Correcting 4 False Assumptions in PG&E's Seismic Source Characterization [2015] and Update [2024] that Caused PG&E to Seriously Underestimate Seismic Hazard at Diablo Canyon Nuclear Power Plant

2024.07.17 presentation to the Petition Review Board of the U.S. Nuclear Regulatory Commission

by Peter Bird, Professor Emeritus, UCLA
consulting to San Luis Obispo Mothers for Peace,
Friends of the Earth, & Environmental Working Group

Bird [2007, *Geosphere*]

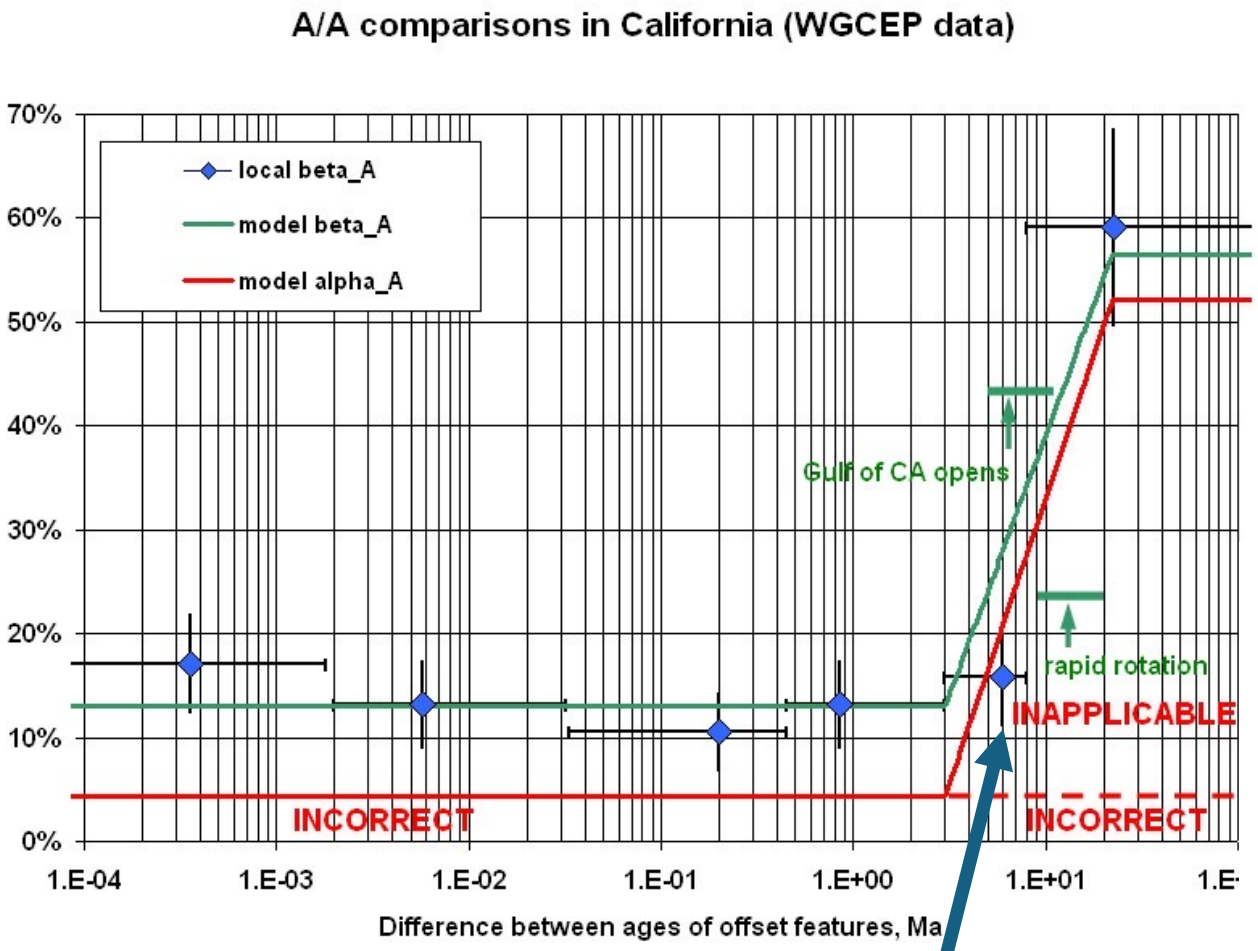
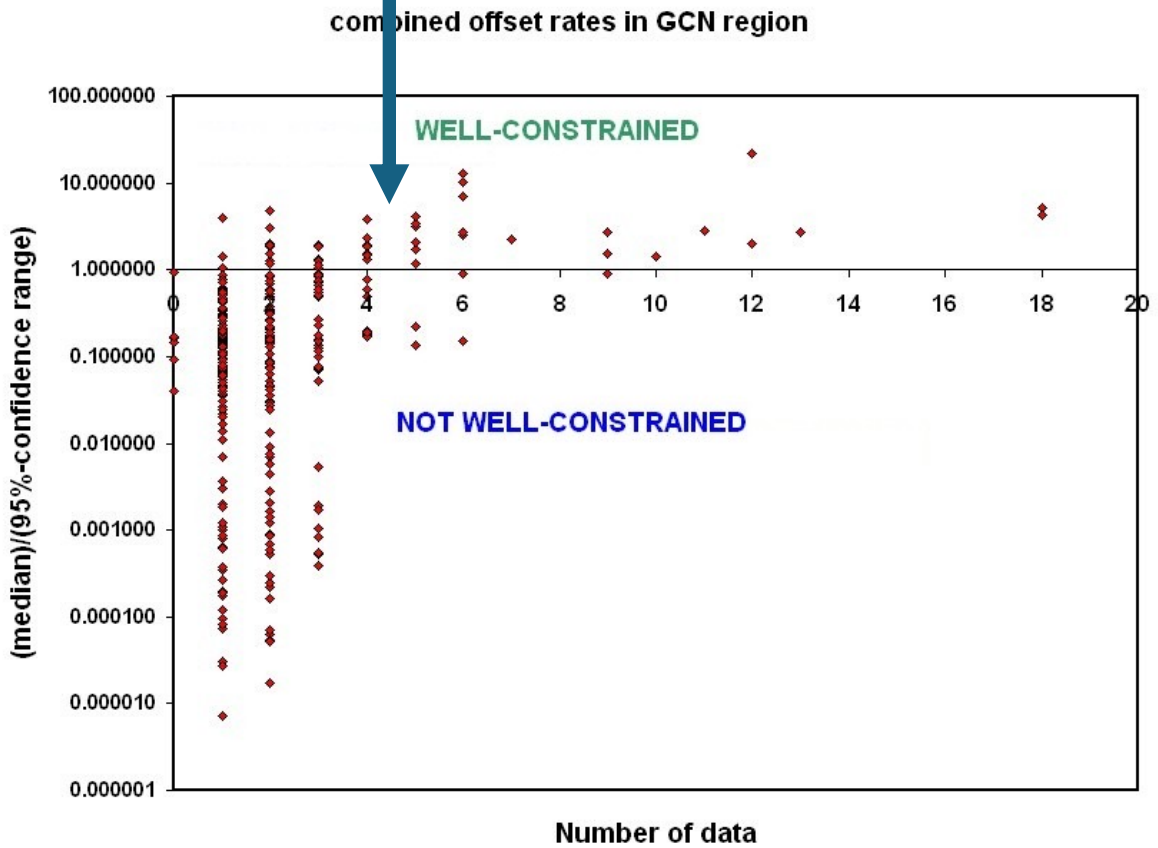
A statistical study of all dated fault offsets in California by *Bird* [2007] showed that the risk of "inapplicability to neotectonics" is <u>constant</u> for offset features with ages of to 3 Ma, and then rises only modestly for features of 5 Ma age [his Figure 8].

Bird [2007] also showed that a well-constrained fault offset rate requires 4~7 offset features, not just 1 or 2 [his Figure 9].

In California, “inapplicability to neotectonics” is only a problem for offset features older than 5 Ma. All younger features are equally relevant.

It takes more than 1 (or 2) offset features to give a well-constrained fault slip rate; actually it takes more than 4!

Therefore, all the structures in the Irish Hills, which formed since 5 Ma, should have been studied and modeled to provide geologic constraints on the rates of thrust-faulting.

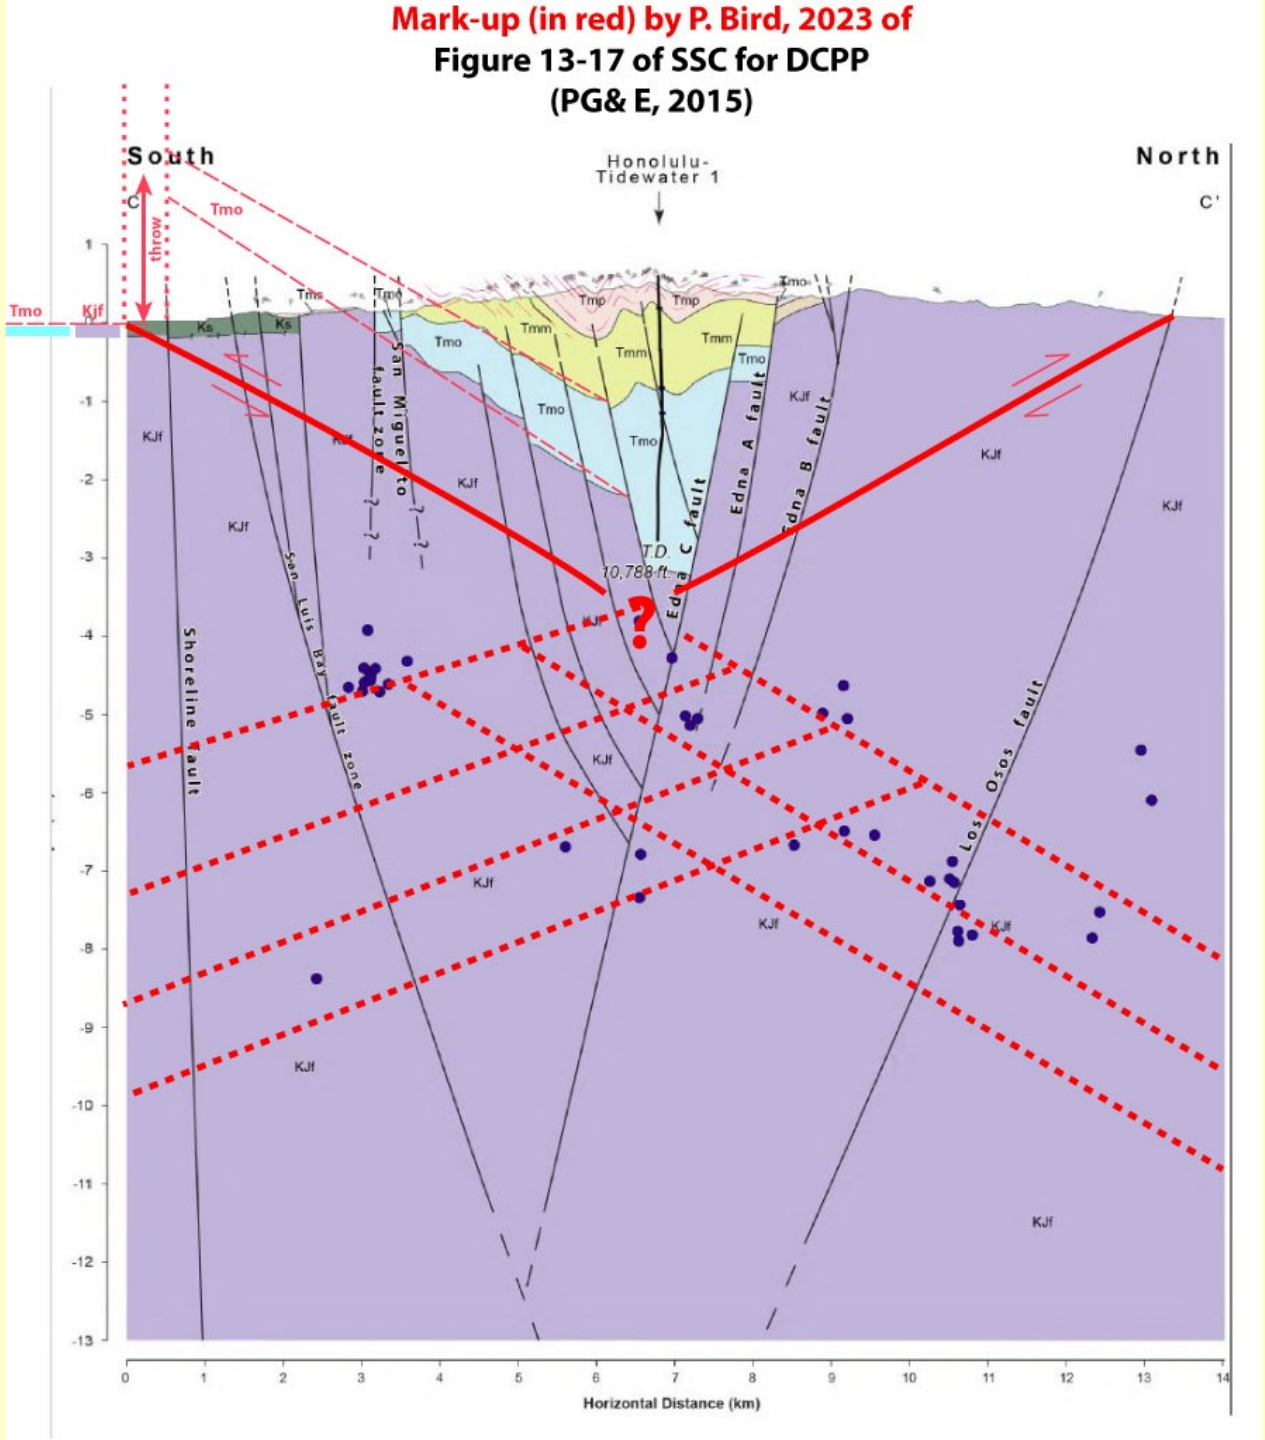
I provided one example in Figure 1 of my March 2024 Declaration: Throw of the Obispo Formation at the San Luis Bay-Inferred Coastline thrust fault is 1.6~2.2 km since 5 Ma, implying throw-rate of 0.32~0.44 mm/year, and fault slip rate of 0.76~1.04 mm/year.

If thrusting in the Irish Hills has been symmetrical(?), then a minimum total thrust slip-rate by this method would be 1.52~2.08 mm/year. (However, this neglects any internal blind thrusts.)

Therefore, all the structures in the Irish Hills, which formed since 5 Ma, should have been studied and modeled to provide geologic constraints on the rates of thrust-faulting.

Long-term-average velocity with respect to DCPP
Model nfeg0402 of *Shen & Bird* [2022]
121°30'
121°15'
121°
120°45'
120°30'
120°15'
120°
35°45'
35°30'
35°15'
35°
34°45'
34°30'
34°15'
0
6
12
18
24
30
36
42
48 mm/a
Velocity
(x 5 Ma):
2 mm/a

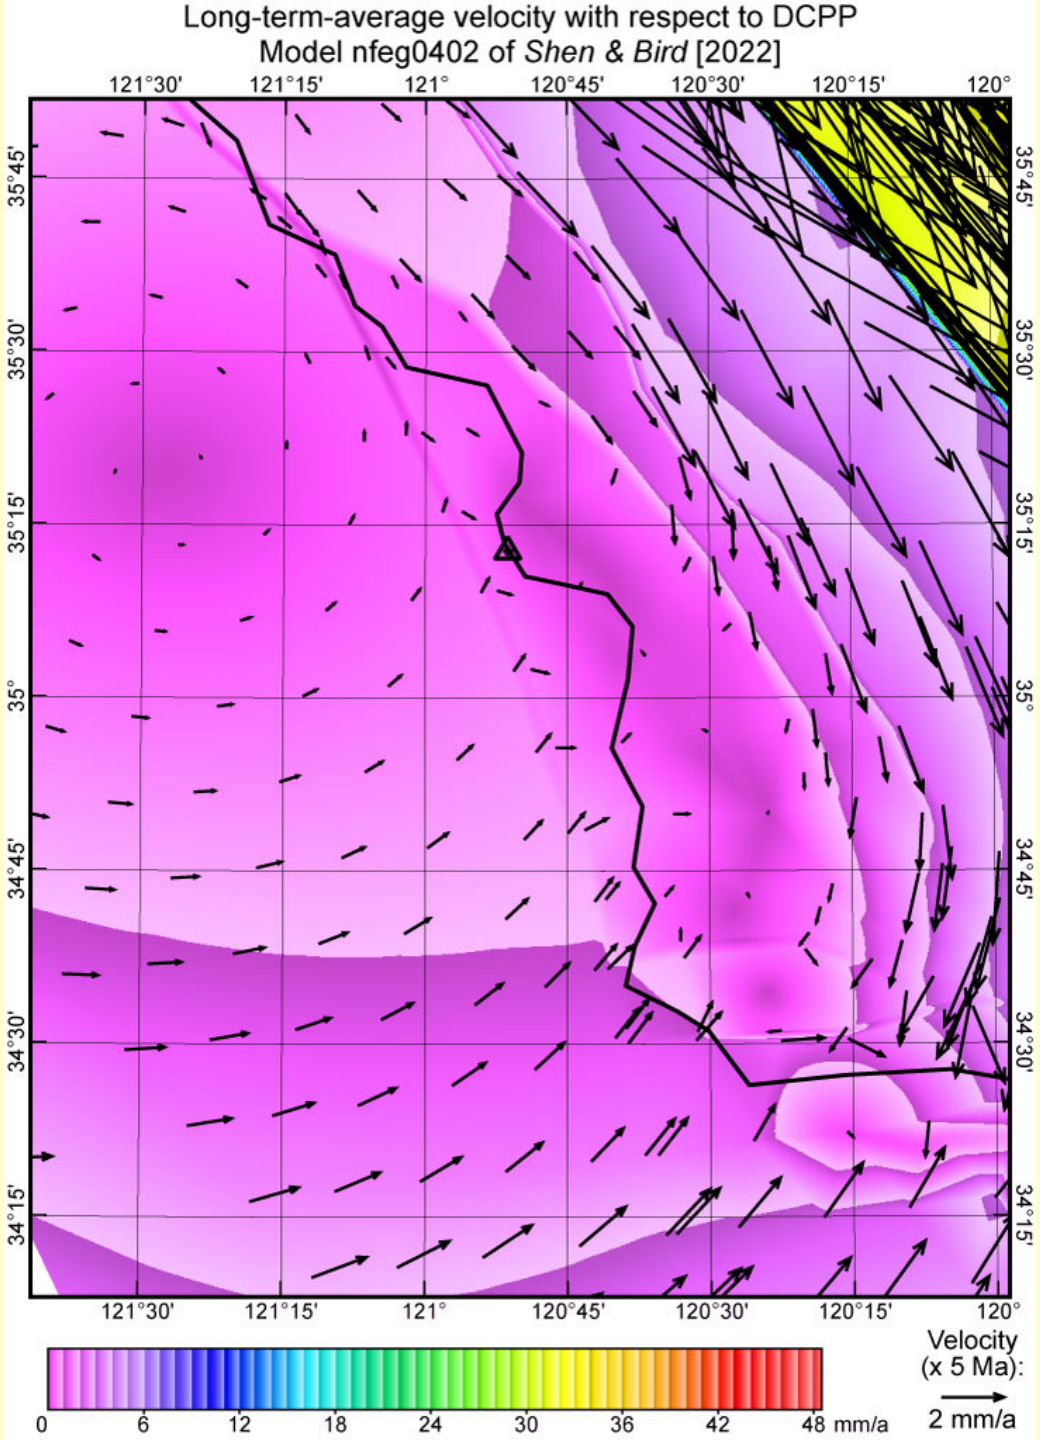
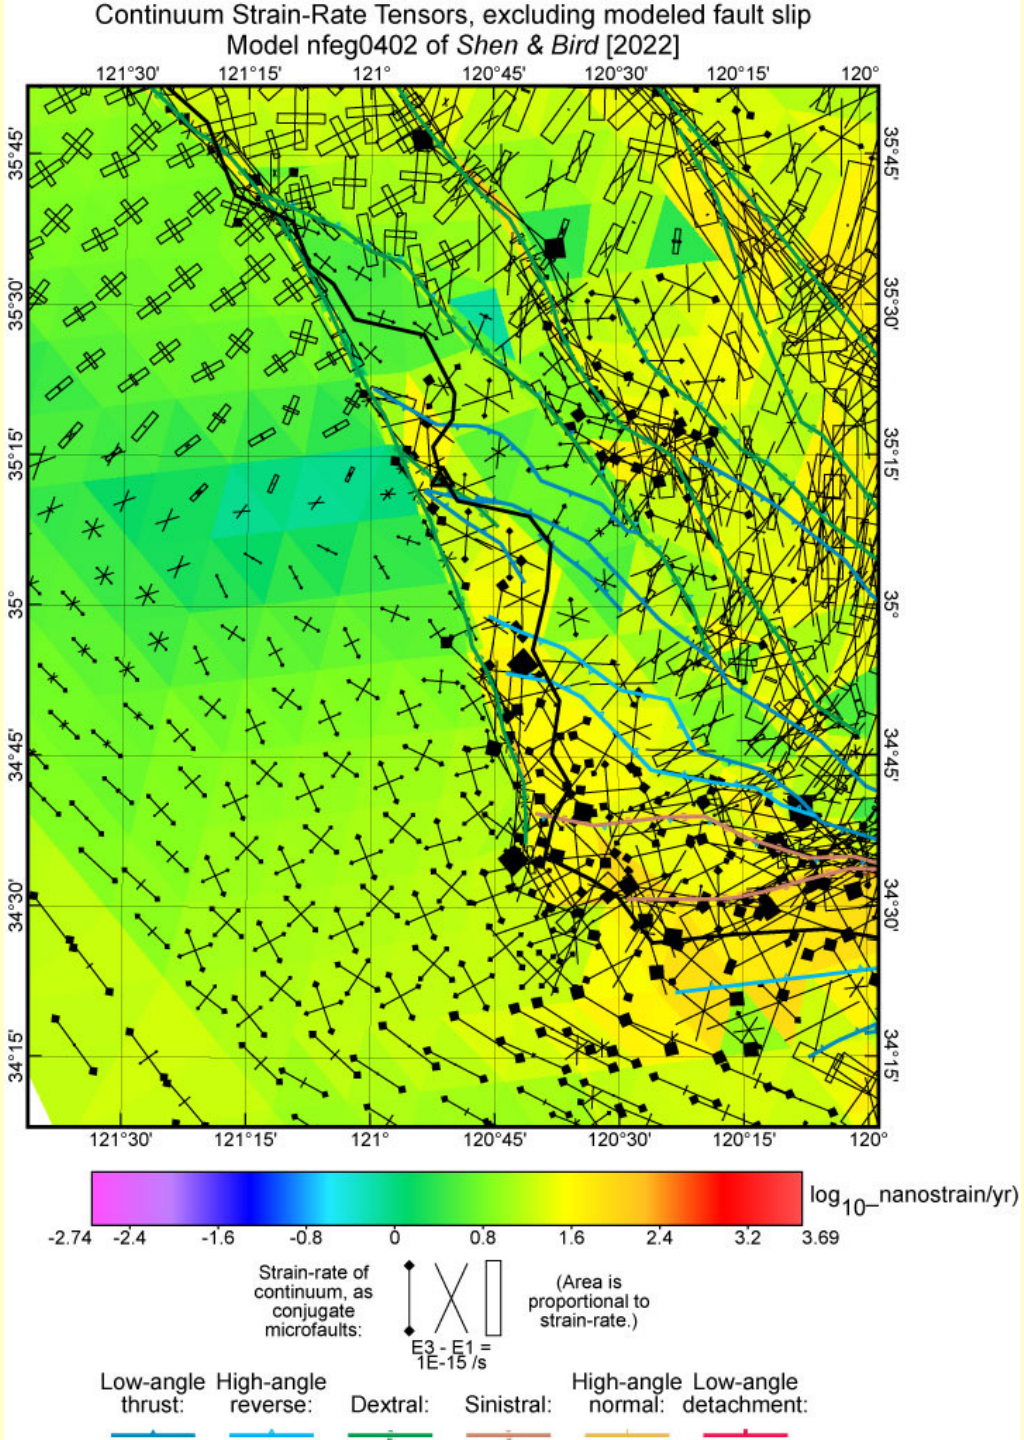
PG&E operated a GPS receiver at DCPP, and *PG&E* [2015] reported the shortening direction across the Irish Hills (~N15°E), but <u>not</u> the rate. The *PG&E* [2024] update adds <u>no new geodetic information</u>!

Both showed ~2 mm/year shortening across the Irish Hills, implying total thrust fault slip rate of (~2 mm/year) / cos(25°) = ~2.2 mm/year.

This is the 3rd of 3 independent analytic estimates developed here.
